20/01/2021

SECTION A-A:

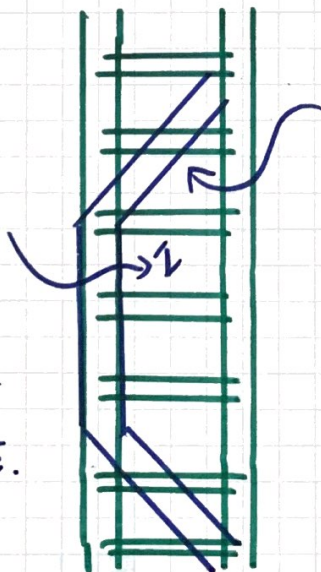
WELDED PLATE ON TOP.

CONCERNED WITH NOT PUTTING A BEAM DIRECTLY BELOW.

FLOOR SPANNING BETWEEN.
PROPOSAL FOR WALL TO SIT ON THE FLOOR PLATE.

PROPOSAL:

MORE SUITABLE TO PUT BEAM DIRECTLY UNDERNEATH WALL.
